KENDALL SITE 5
314 Main Street
Cambridge, MA 02142

PROPOSED REVISED TRANSPARENT GLASS EXTENTS

TO BE FORMALIZED IN FORTHCOMING ADDENDUM

GROUND FLOOR SOUTH FACADE TRANSPARENCY MODIFI
SCALE: 1/8" = 1'-0"

1 SOUTH ELEVATION
SCALE: 1/16"=1'-0"

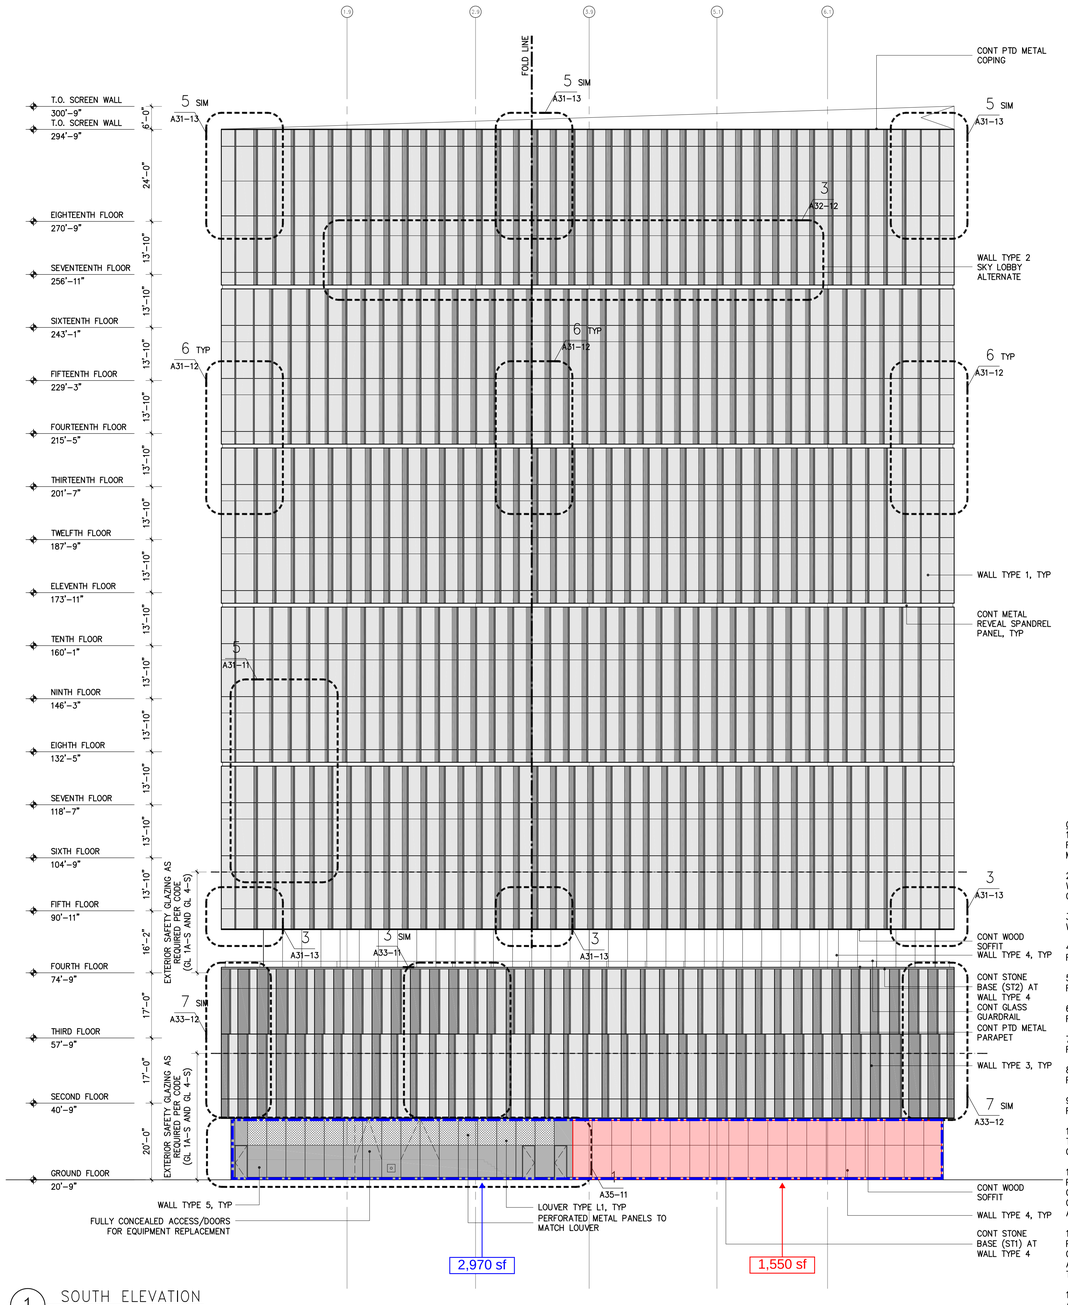
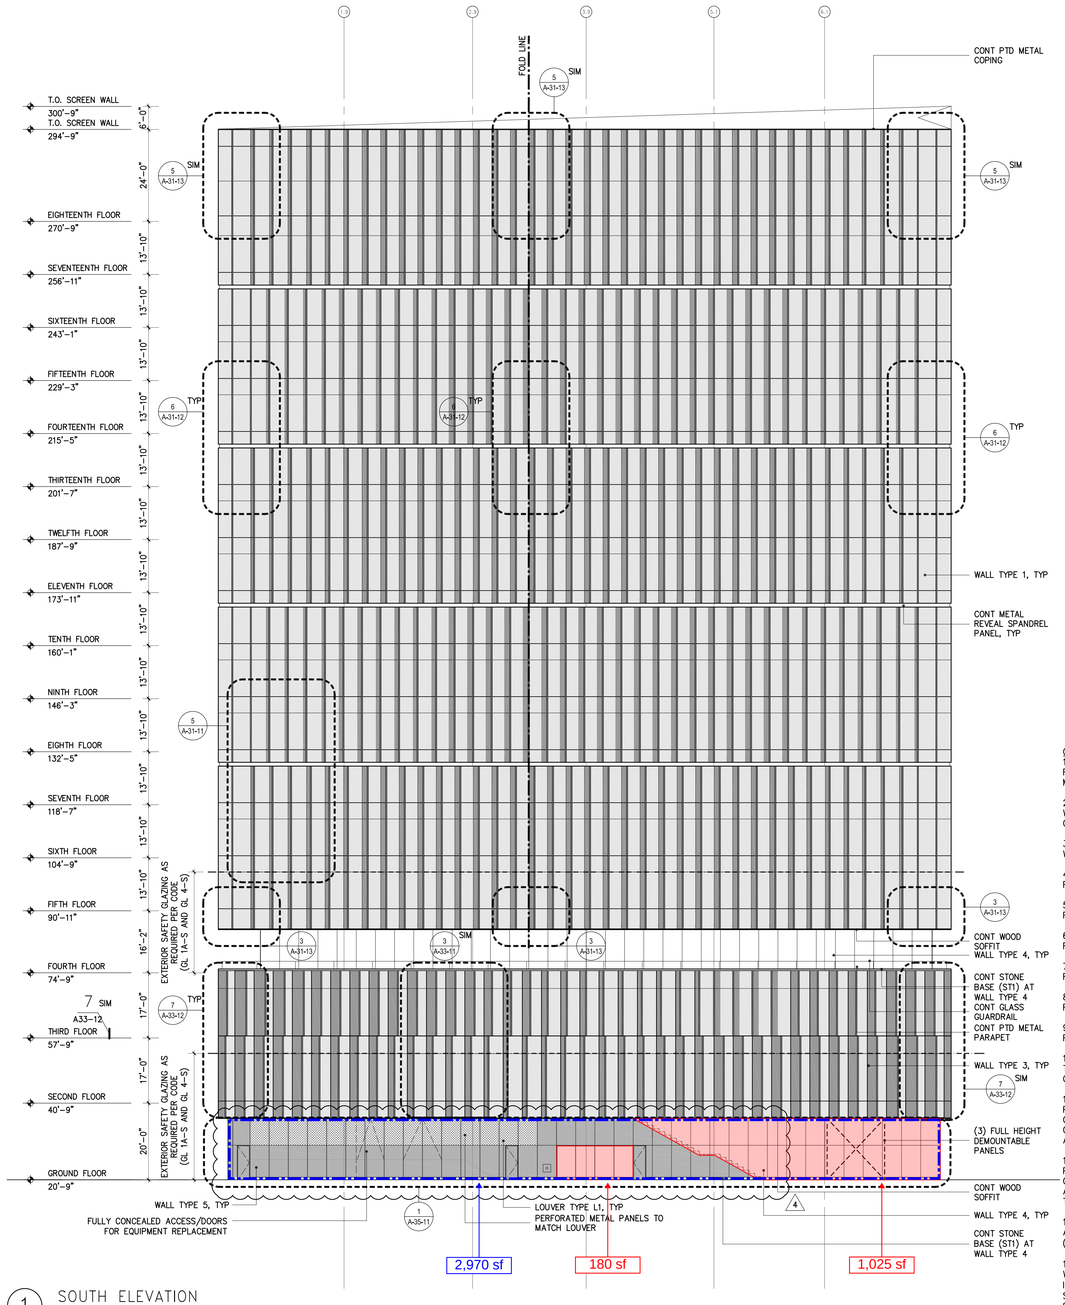
TRANSPARENCY CALCULATION PER WMA:

South Elevation Overall: 2,970 sf
South Elevation Transparency: 1,205 sf
Percentage Transparency: 40.5%

Base Building 100% CD

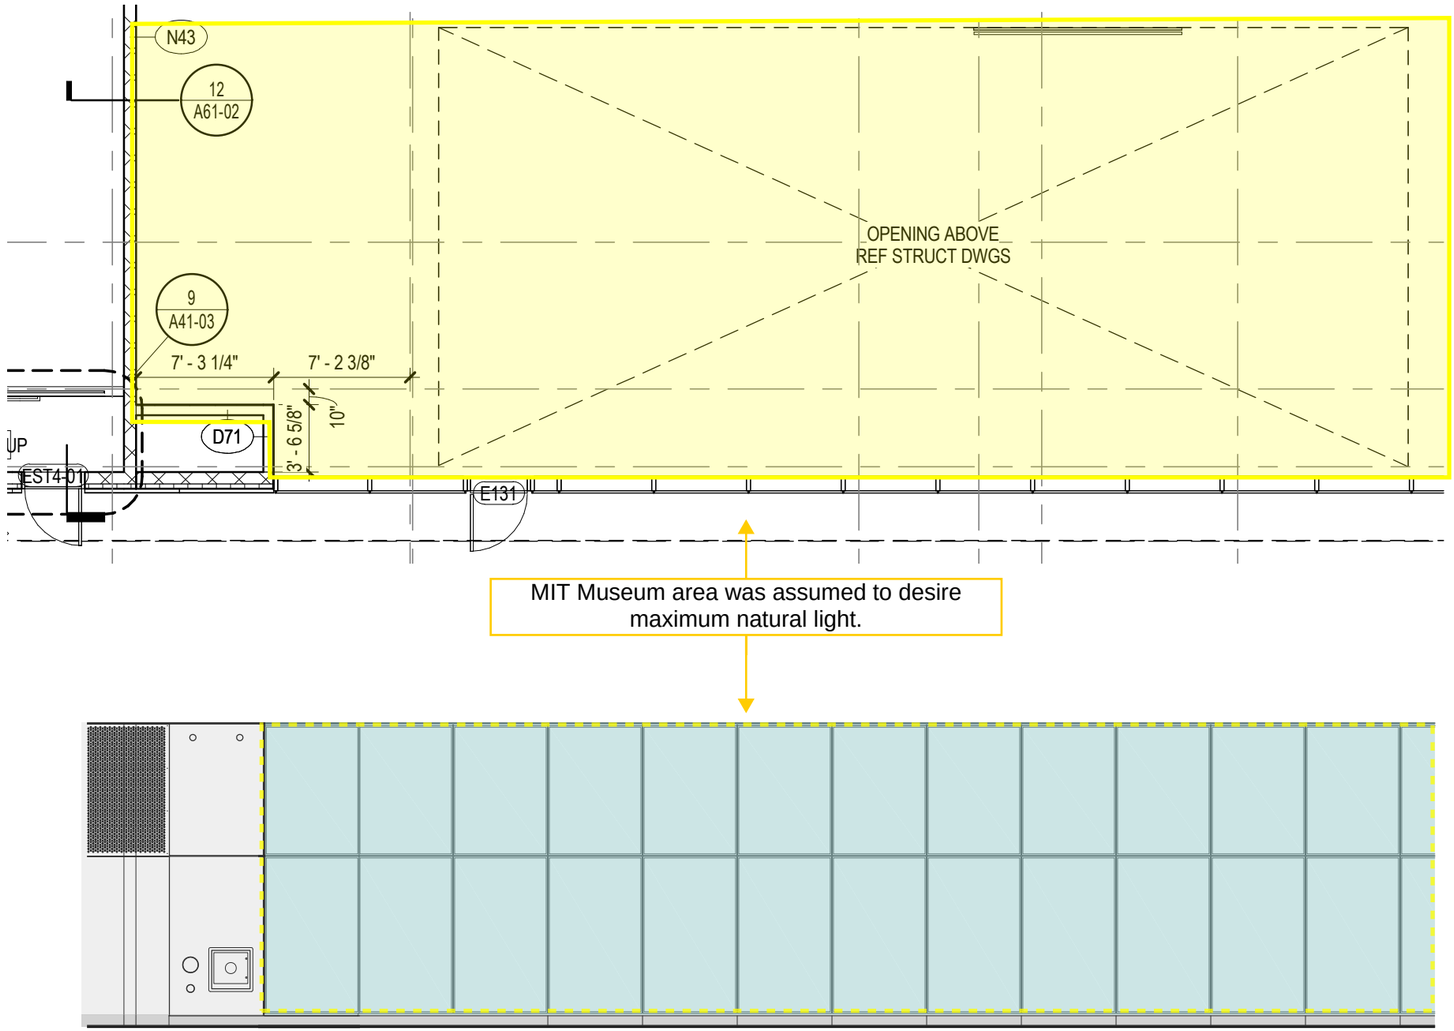
The development of the MIT Museum is naturally behind that of the base building's core and shell. As a result at the time of 100% CD the base building team assumed maximum transparency on the ground floor.

Current Plan

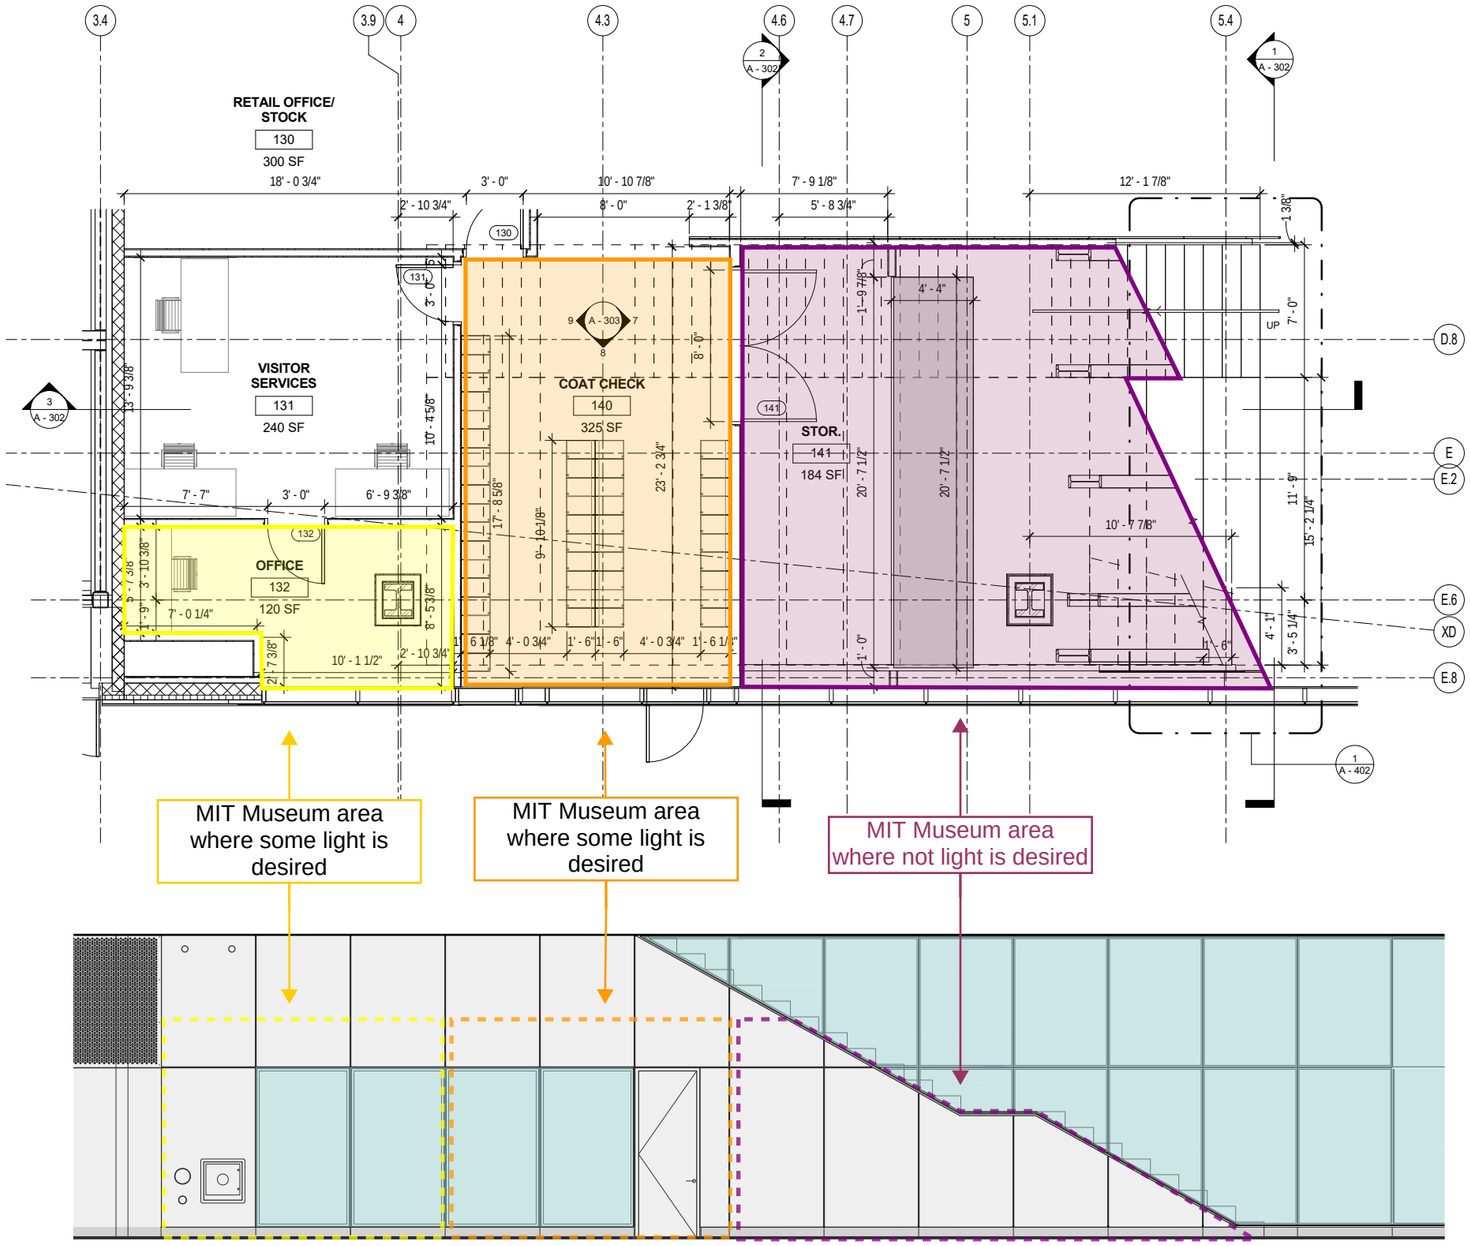
The current scheme for the MIT Museum is to locate a public, grand stair at the perimeter of the facade with various program elements occupying the space below. The south facade has been updated to respond more directly to these program requirements.
